WURLITZER SERVICE SLANTS

SUBJECT: Model 3500 Series Phonographs equipped with Four Quarter Credit Accumulators shipped from factory prior to the following Serial Numbers:

Model 3500 - 763864
Model 3560 - 774948
Model 3510 - 771060

Figure 1.

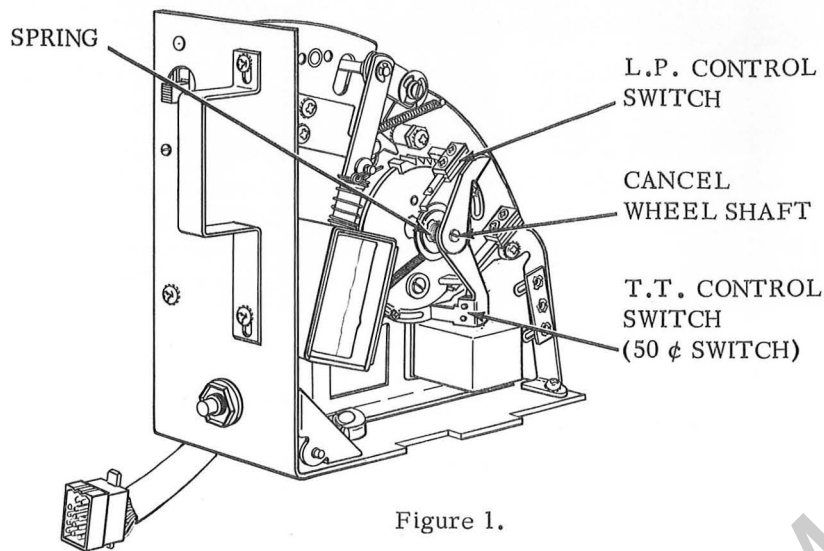
COMPLAINT: On Model 3500 Series Phonographs equipped with the Four Quarter Credit Accumulator, five or eight credits are established on deposit of first quarter.

REASON FOR CHANGE: The above complaint, although isolated, is caused by Cancel Wheel "bounce" in the Coin Register Mechanism. This problem can be eliminated by installing a spring on the Cancel Wheel Shaft. The addition of this spring will eliminate Cancel Wheel "bounce" and prevent the extra credit condition from reoccurring. It is recommended that this change be incorporated on all Model 3500 Series Phonographs equipped with Four Quarter Credit Accumulators to preclude the occurrence of the above stated complaint. Phonographs shipped from the factory after the Serial Numbers listed under SUBJECT will have this change incorporated.

1. Remove the Coin Register Mechanism from the Phonograph.
2. Remove screw securing the LP CONTROL SWITCH, shown in Figure 1, and remove the LP CONTROL SWITCH from CANCEL WHEEL SHAFT. Retain screw for reassembly.
3. Remove screw securing the TT CONTROL SWITCH (50 Cent Switch), shown in Figure 1, and remove TT CONTROL SWITCH (50 Cent Switch) from CANCEL WHEEL SHAFT. Retain screw for reassembly.
4. Remove Retaining Ring from CANCEL WHEEL SHAFT. Retain Retaining Ring for reassembly.
5. Install SPRING, Part No. 64780, on CANCEL WHEEL SHAFT.
6. Depress SPRING and reinstall Retaining Ring, removed in Step 4, on CANCEL WHEEL SHAFT.
7. Reinstall the TT CONTROL SWITCH (50 Cent Switch) and secure to Coin Register Mechanism with screw removed in Step 3.

8. Reinstall the LP CONTROL SWITCH and secure to Coin Register Mechanism with screw removed in Step 2.
9. Adjust the LP CONTROL SWITCH and TT CONTROL SWITCH (50 Cent Switch) as follows:

- a. Manually actuate the 25 CENT LEVER, HUB AND STUD ASSEMBLY to permit the 25 CENT ACCUMULATOR WHEEL and the CANCEL WHEEL to advance to the 25 cent credit position.
 - b. Loosen LP SWITCH ADJUSTING SCREW and position the LP SWITCH so that the switch closes, with good wiping action, on the 25 cent credit position.
 - c. Manually actuate the CANCEL SOLENOID PLUNGER and cancel of one credit. The LP SWITCH should open with approximately .025" clearance between contacts. Tighten Adjusting Screw.

- a. Manually actuate the 50 CENT LEVER, HUB and STUD ASSEMBLY to permit the 50 CENT ACCUMULATOR WHEEL and the CANCEL WHEEL to advance to the 50 cent credit position.
 - b. Loosen the TOP TUNE CONTROL SWITCH (50 Cent Switch) Adjusting Screw and position the TOP TUNE CONTROL SWITCH (50 Cent Switch) so that the switch closes, with good wiping action, in the 50 cent credit position.
 - c. Manually actuate the CANCEL SOLENOID PLUNGER and cancel off one credit. Verify that the TOP TUNE CONTROL SWITCH (50 Cent Switch) opens with approximately .025" clearance between contacts. Tighten Adjusting Screw.
10. Reinstall Coin Register Mechanism in Phonograph.
